COUNCIL ASSESSMENT REPORT – MODIFICATION APPLICATION

HUNTER AND CENTRAL COAST REGIONAL PLANNING PANEL

PANEL REFERENCE & DA NUMBER	PPSHCC -147 – MA2022/00286 (DA2019/00711) File Number 2019/39309 EXP No 1 National Park Street Pty Ltd v Newcastle City Council
PROPOSAL	Section 4.56 Modification to a Development Application for a mixed used development comprising demolition, retail, commercial, public spaces, residential apartments, associated parking, staging, and stratum subdivision.
ADDRESS	Lot 1171 in DP 858465; Lot 1181 in DP 596950; Lot 99 DP1134475; Lot 1 in DP 741514; and Lot 100 in DP 612505. 1, 17, 19 National Park Street and 434 King Street Newcastle West
APPLICANT	GWH BUILD DEVELOPMENTS PTY LTD
OWNER	EXP NO 1 National Park Street Pty Ltd
MOD LODGEMENT DATE	26 August 2022
ORIGINAL DA DETERMINATION DATE	21 September 2020 Jurisdiction: Class 1 File Number 2019/393097
APPLICATION TYPE	Modification Application under 4.56
REGIONALLY SIGNIFICANT CRITERIA	Clause 2, Schedule 6 of <i>State Environmental Planning Policy (Planning Systems) 2021</i> : General development with a CIV greater than \$30 million. Section 275 of the <i>Environmental Planning and Assessment Regulation 2021</

Extract 3 – Street tree planting concept

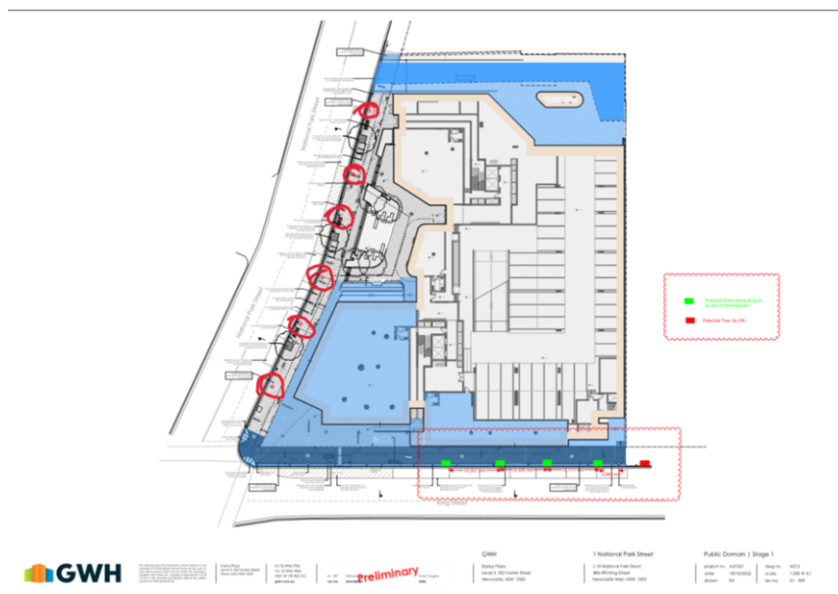
Consultation has been done with CN City Greening team and a concept proposal for street tree planting on King St and replacement of the removed tree has been provided (See Extract 3 below).

This information has been relayed to the applicants and no objections have been raised.

The design for the street awnings and street tree installation can be resolved at the relevant construction certificate stage as part of the Roads Act application.
